Comments to GTR Draft SGS-7-11	Status: 06.01.2010
Nr .	Pa ge	Paragraph/figure/table	Recommendation	Comment/Justification
1	6	3	2. [...] When the vehicle is started, the shut-off valve is opened and hydrogen gas is allowed to flow from the Hydrogen Storage System.	In case of LH2 extraction of liquid hydrogen should be also allowed. According to Figure 4 the coolant heat exchanger does not contain to the LH2 storage system.
2	7	3	3. [...] As with gasoline tanks, hydrogen storage containers, whether compressed gas or liquefied hydrogen, are usually mounted transversely in the rear of the vehicle.	Both LH2 and CGH2 can also be mounted in driving direction in the middle tunnel of the vehicle
4	8	3.2	8. The hydrogen storage system consists of all components that form the primary pressure boundary of the stored hydrogen gas in the system.	Cover LH2
5	9	3.2.1	10. [...] “d) the thermally-activated pressure relief device(s) (TPRD)”	In case of more than one container it should be devices

Figure 4. Typical Liquefied Hydrogen Storage System
Delete Original Figure 4

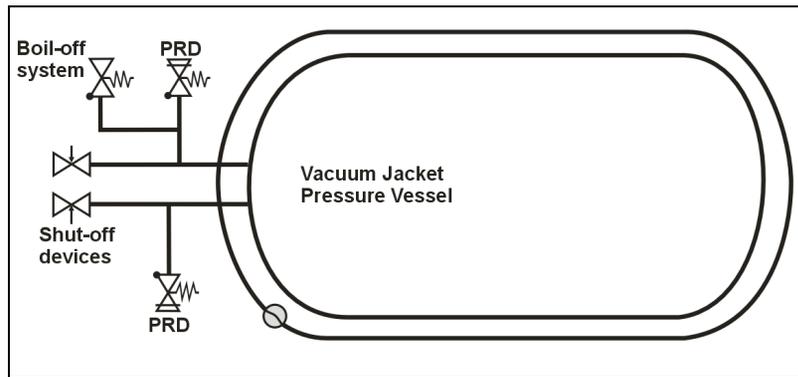
7	10	3.2.2	<p>3.2.2 LIQUEFIED HYDROGEN STORAGE SYSTEM (put in separate section)</p> <p>16. As noted previously, hydrogen gas has a low energy density per unit volume. To overcome this disadvantage, the liquefied hydrogen storage system (LHSS) maintains the hydrogen at cryogenic temperatures in a liquefied state.</p> <p>17. A typical liquefied hydrogen storage system (LHSS) is shown in Figure 4. Actual systems will differ in the type, number, configuration, and arrangement of the functional constituents. Ultimately, the boundaries of the LHSS are defined by the interfaces which can isolate the stored liquefied</p>	New section for LH2

A typical liquefied LHSS shown in Figure 4 regularly consists of the following components:

- a) liquefied hydrogen storage container(s),
- b) shut-off devices,
- c) Pressure Relief Devices (PRDs),
- d) a Boil-off system,
- e) all components, fittings and fuel lines between the container(s) and the above components.
